**Invitation No: IB-035-24**  
**Title: HSC Roof Replacement BP-2**  
**Addendum No. 2**

**IB-035-24**  
**Addendum 2**  
**Bidder Questions**

Exhibit C

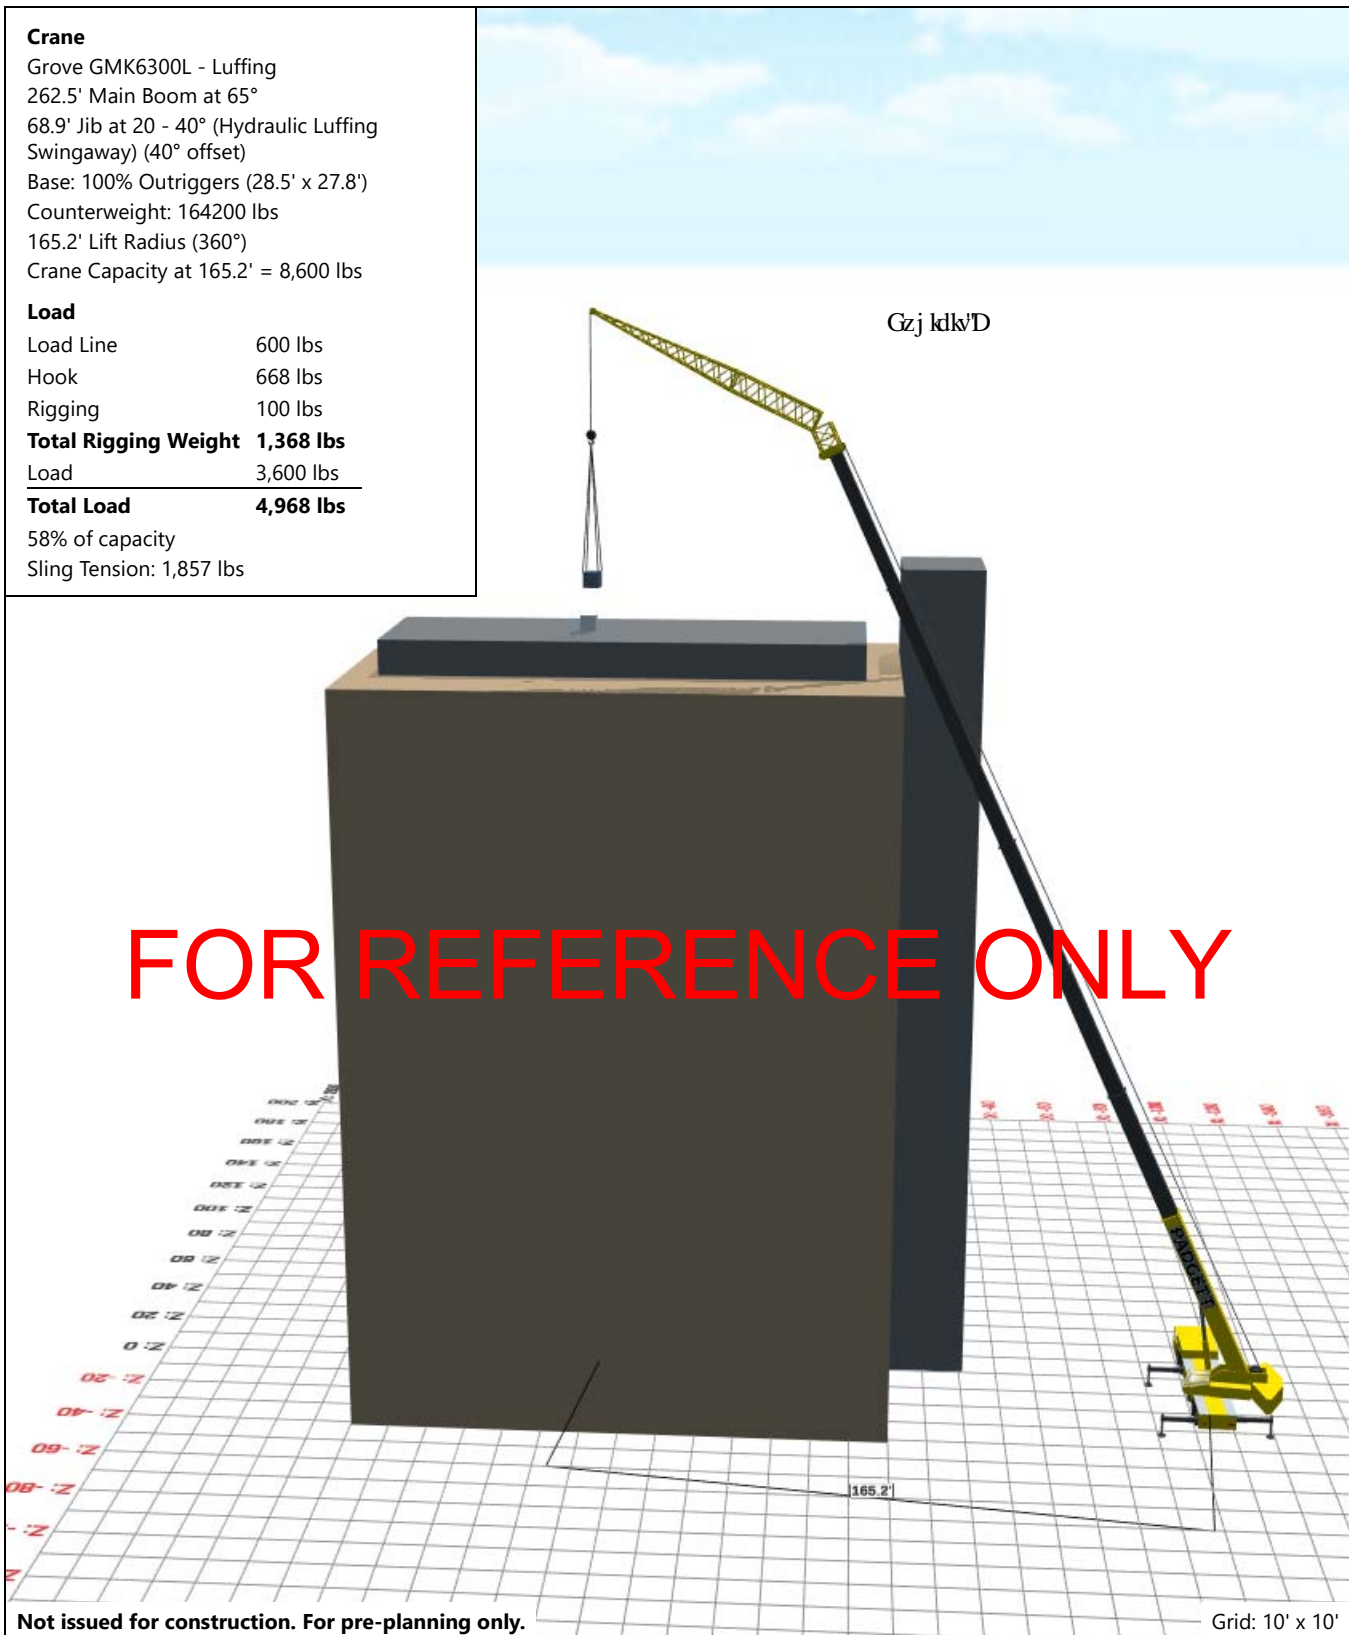
2. Are there restrictions to utilizing a crane to reach Bldg 55A if performed evenings or weekends?

University Response: Using a crane is possible under the following guidelines:

- The crane is scheduled on the weekend, Saturday preferred.
- The contractor is to provide a pick-plan
- The contractor is to receive approval from UofL
  - This entails the pick-plan and a meeting with the Physical Plant Department (PPD) Project Managers and the UofL Department of Environmental Health and Safety (DEHS).
- See below Exhibits for references to crane positioning/planning for previous projects
